REMARKS

This Amendment responds to the Office Action mailed July 13, 2004.

AMENDMENTS TO THE DRAWINGS

FIG. 2

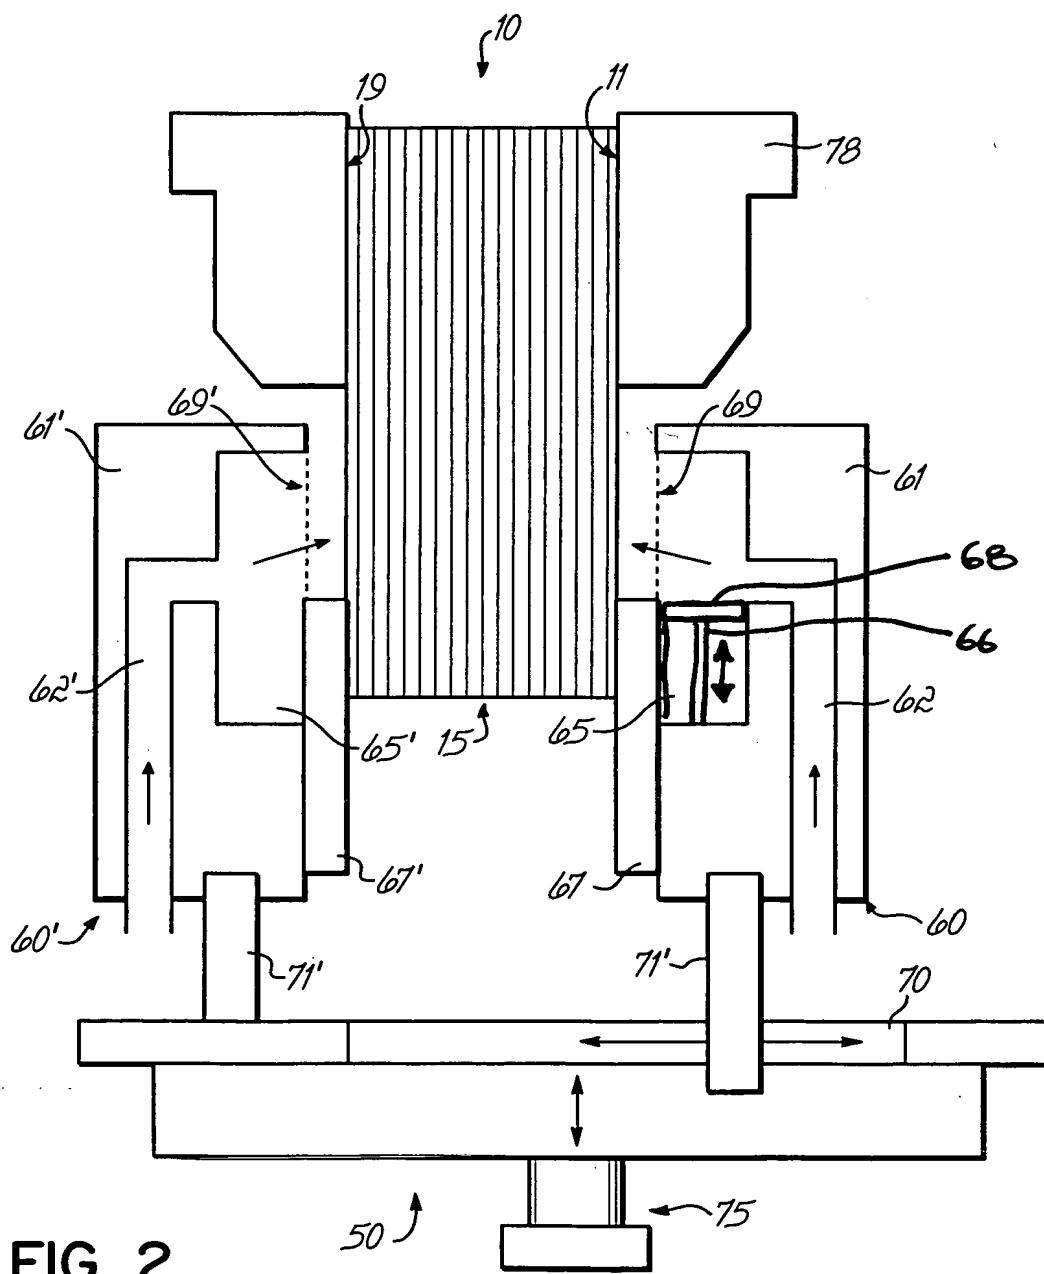
The drawings were objected to for failure to depict the piston and sealing body recited in claim 9. FIG. 2 has been changed to include these features of the invention and the Specification has been amended accordingly. A marked up version of FIG. 2 and a corrective formal drawing are submitted herewith for the Examiner's review and approval. Applicant submits that these items are described elsewhere in the originally filed Application and, therefore, no new matter has been added by the change to FIG. 2 or the amendment to the Specification. Pending the Examiner's approval, Applicant respectfully requests that the objections to the drawings be withdrawn.

The attached drawing sheet includes changes to Fig. 2. This sheet, which includes Figs. 1 and 2, replaces the original sheet including Figs. 1 and 2. Fig. 2 has been changed to include the piston and sealing body recited in claim 9.
